ADDENDUM NO. 1

March 19, 2025

School District of Haverford Township | Coopertown Elementary School Renovations & Additions
CRA Project No. 3758

A4.5

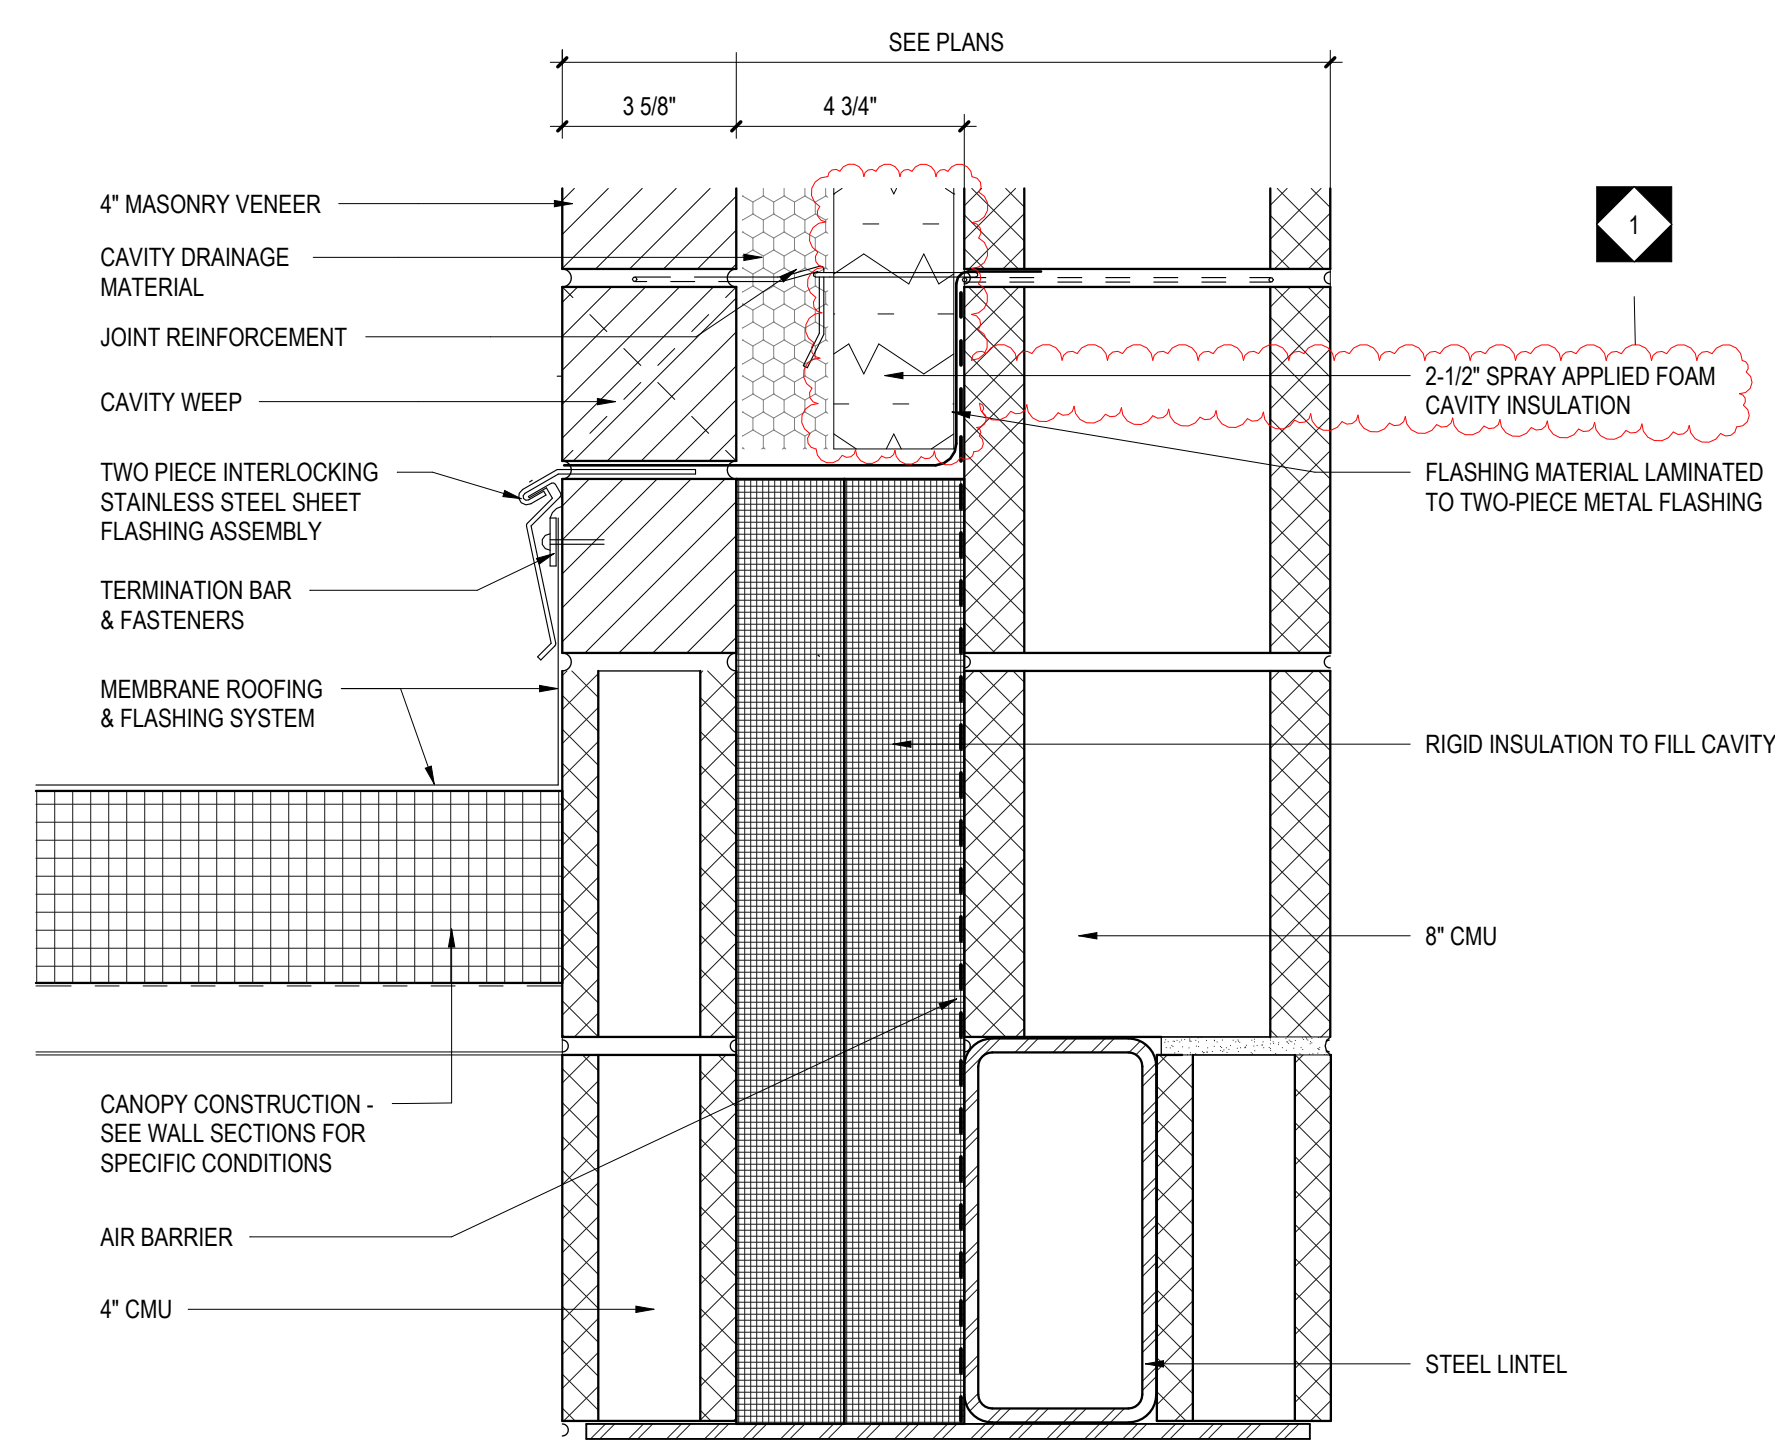
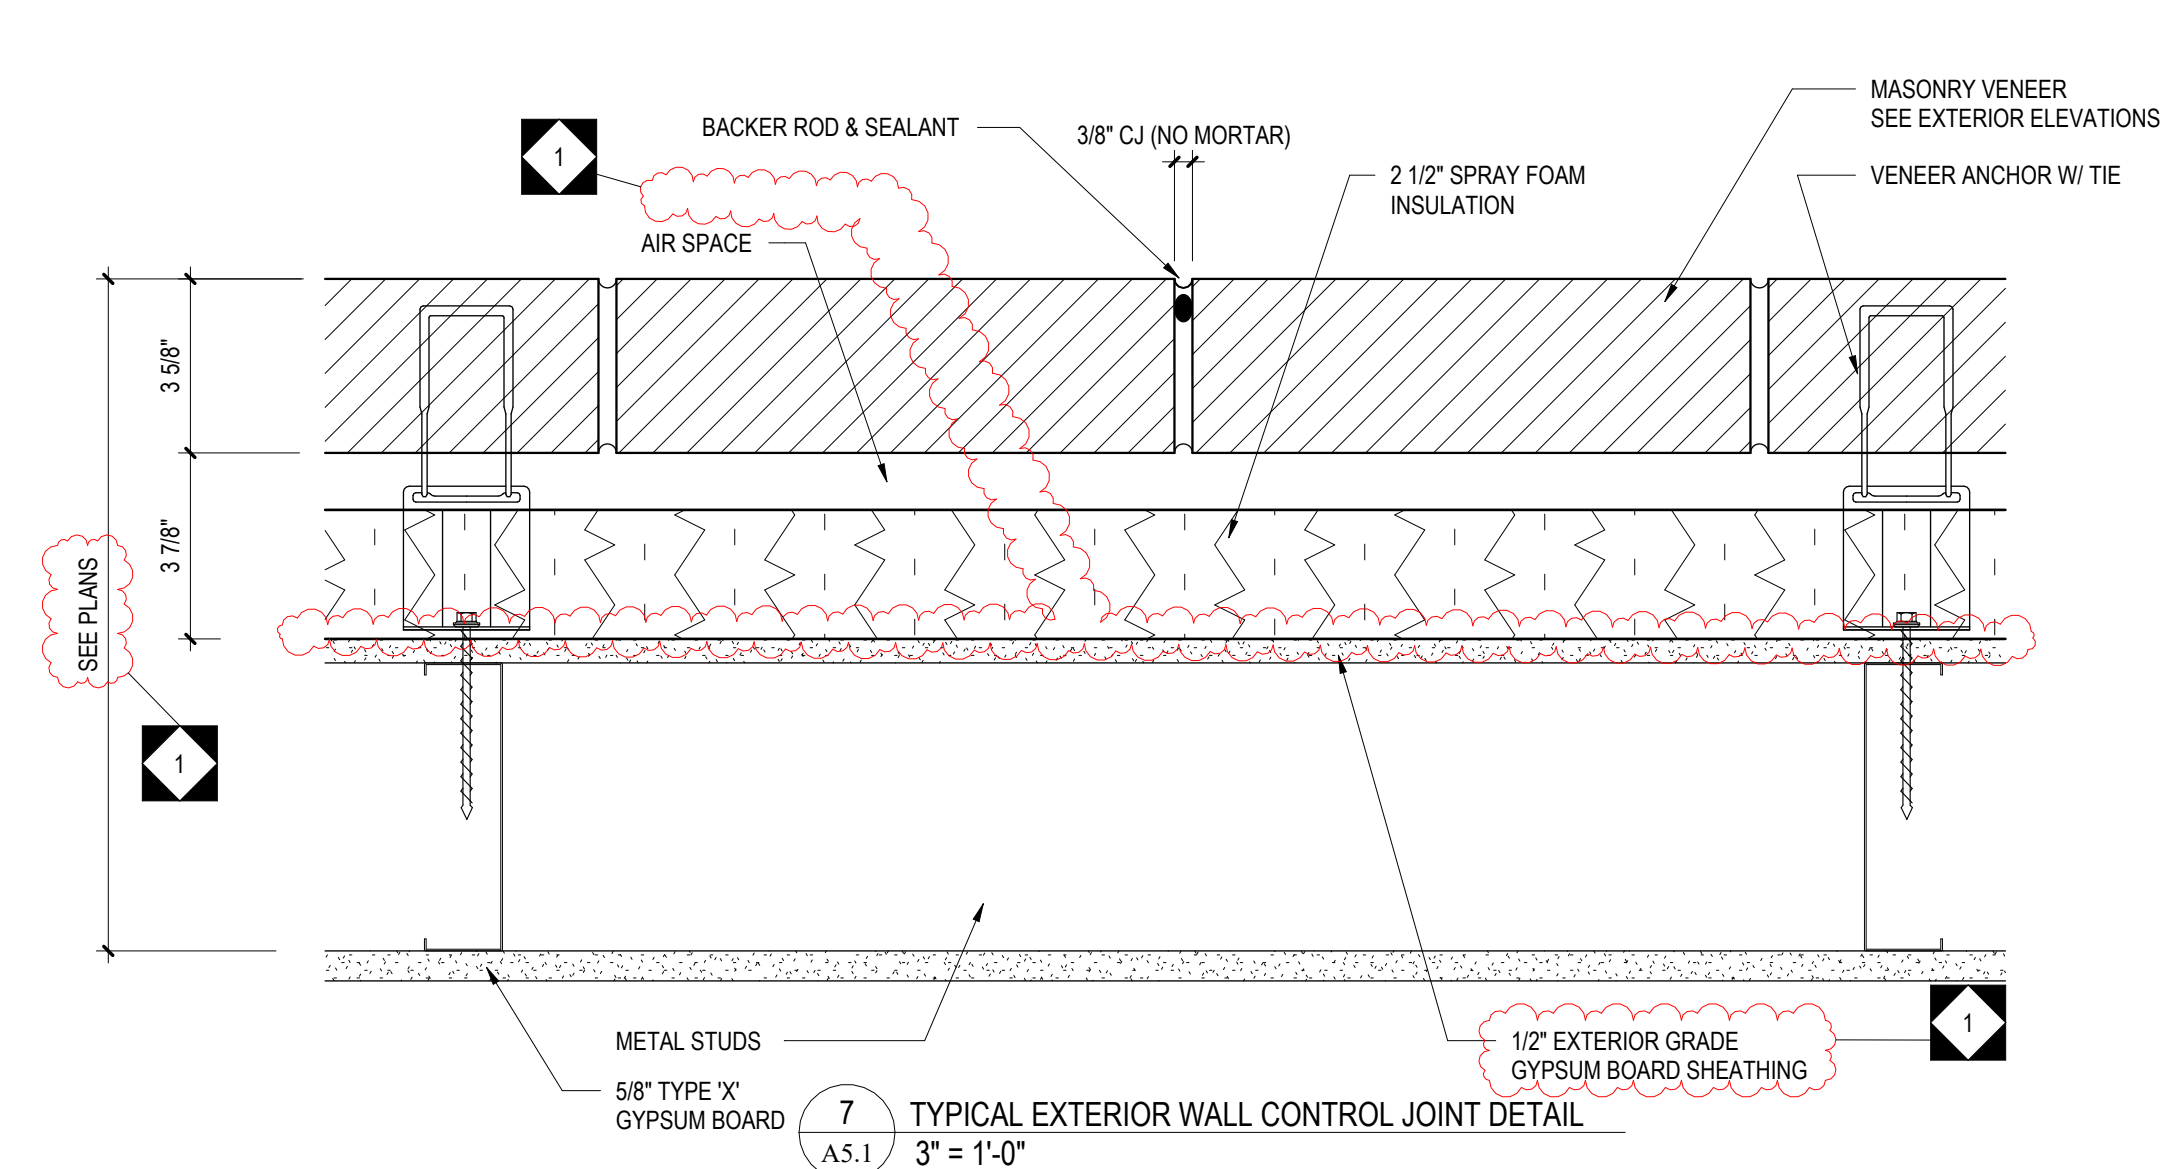
1. ADD – note to boulders and stone bed
2. REMOVE – bench at front entrance
